**Planning Board Meeting Agenda
Brunswick Town Hall
85 Union Street – Council Chambers
Tuesday, February 10, 2026 @ 6:00 PM**

4. **Case No. 25-059 – MaineHealth Mid Coast Cancer Center Renovation:** The Planning Board will review and act upon a **Site Plan Amendment** application submitted by Pine Tree Engineering on behalf of the property owner, Mid

DRAFT FINDINGS OF FACT SKETCH PLAN MAJOR DEVELOPMENT REVIEW PLANNING BOARD

DATE: 10.28.2025
SHEET TITLE AND NUMBER:
AS3.00
CIVIL DETAILS

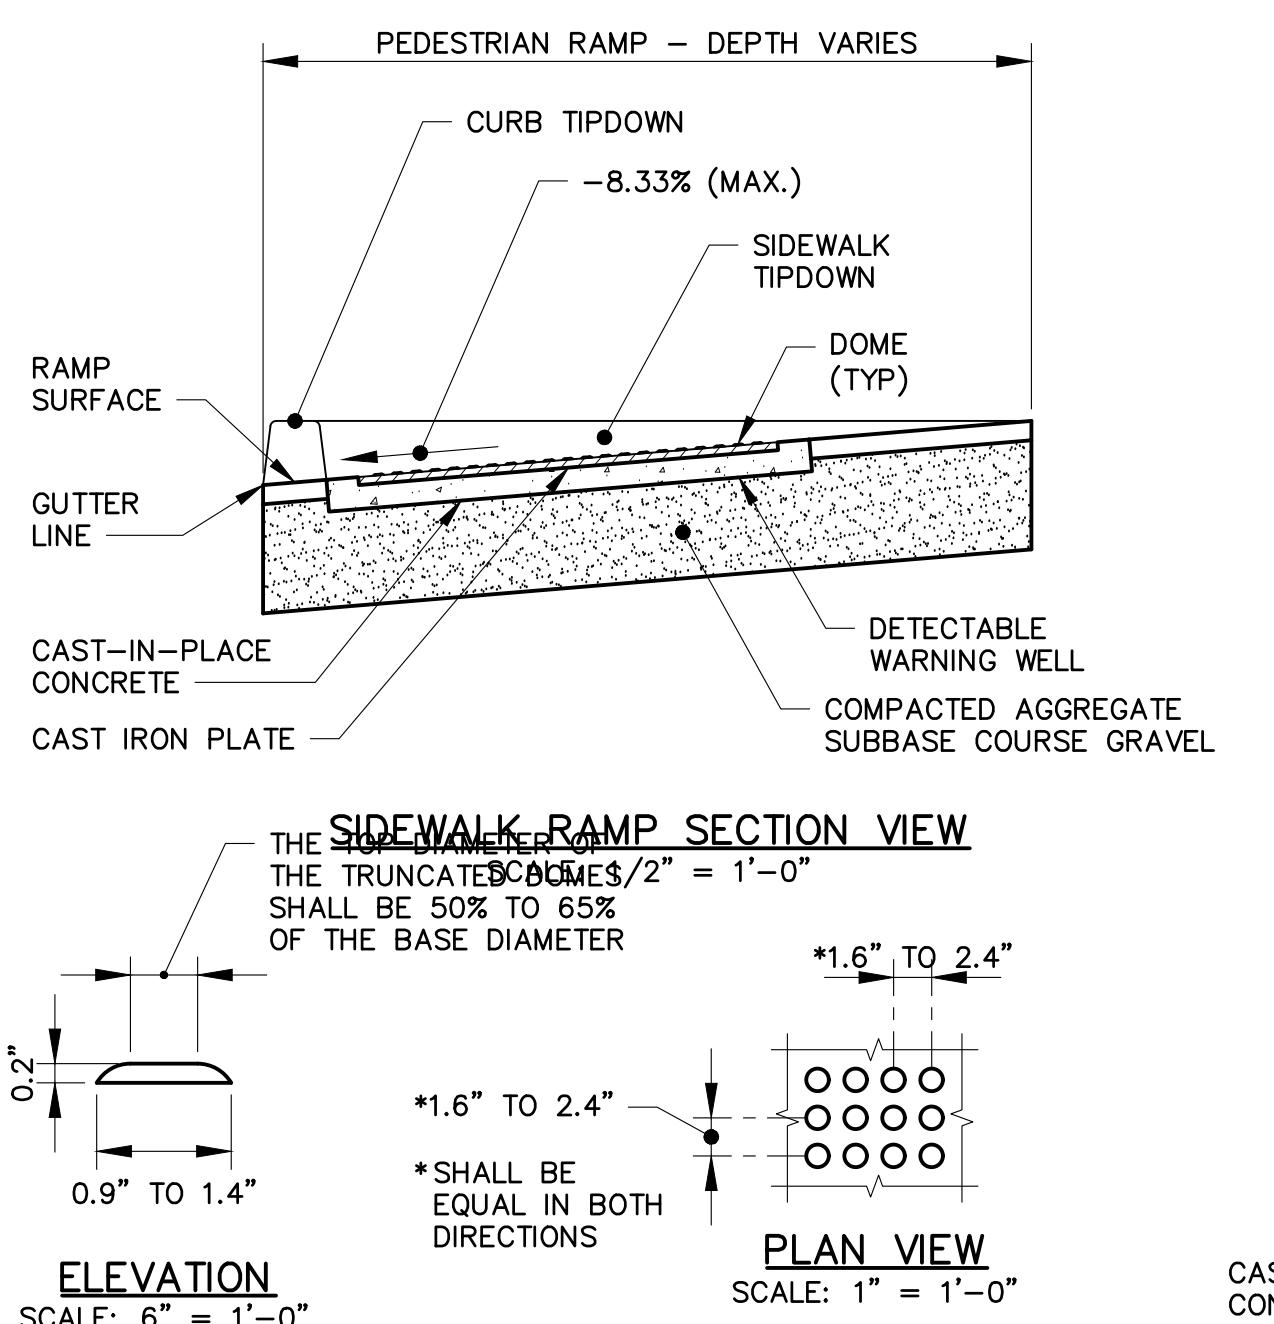
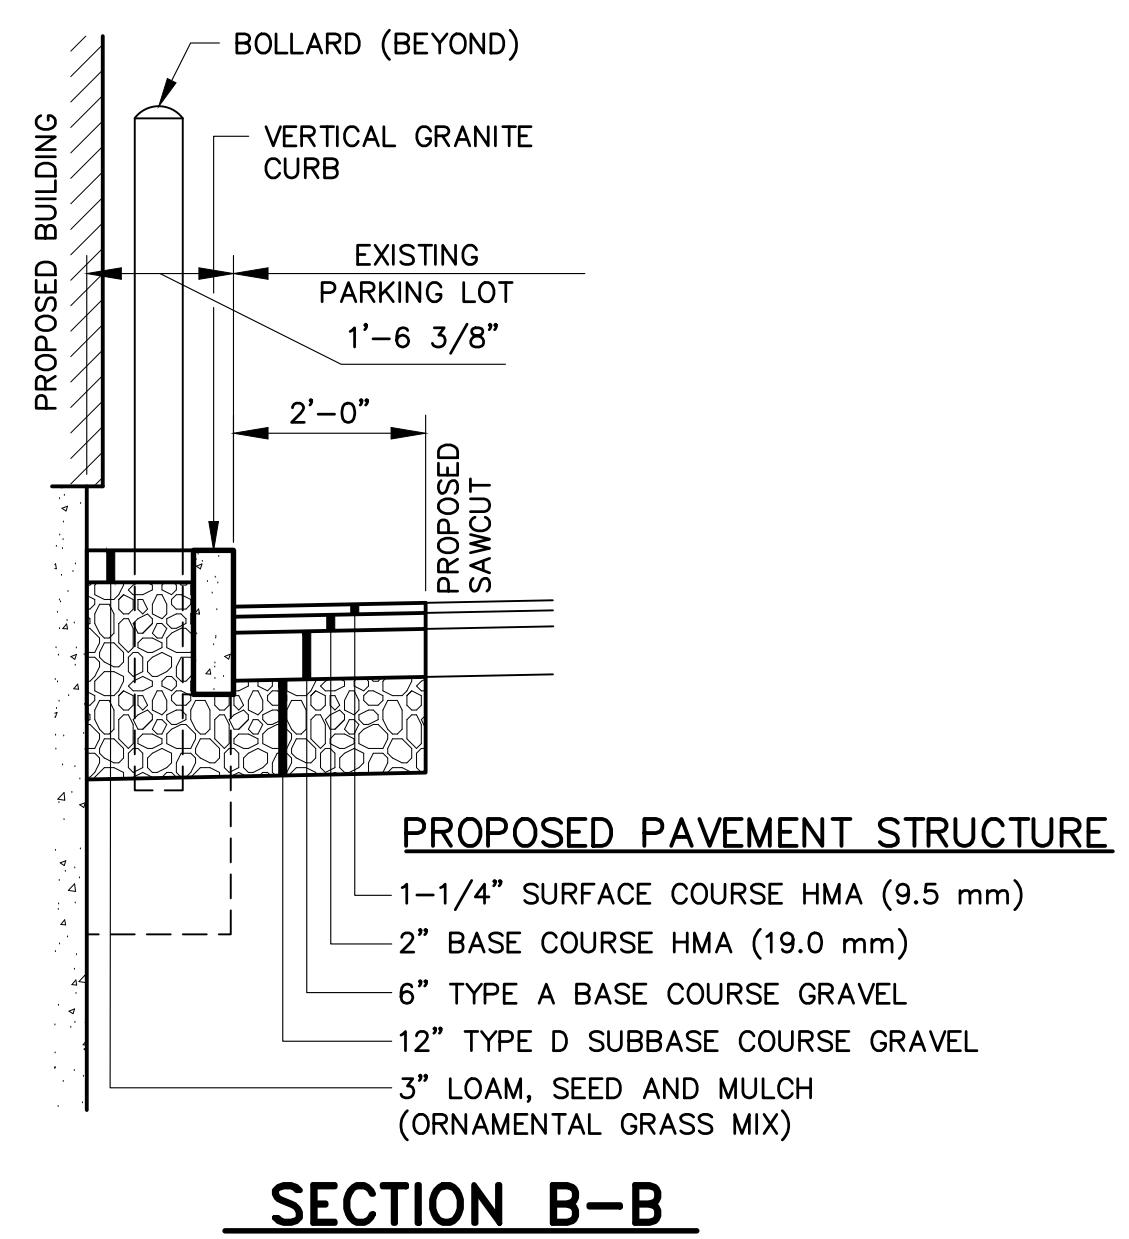
3. Add ornamental grass along parking lot side of pharmacy, near bollards	See Section B-B on AS3.00 Civil Details
Architecture Comments	
4. Review Cooks Corner Design Standards, specifically Section 3.4 Fa?ade Requirements, and within 3.4.j.	See Exhibit 8: Cook's Corner Design Standards Narrative.
Engineering Comments
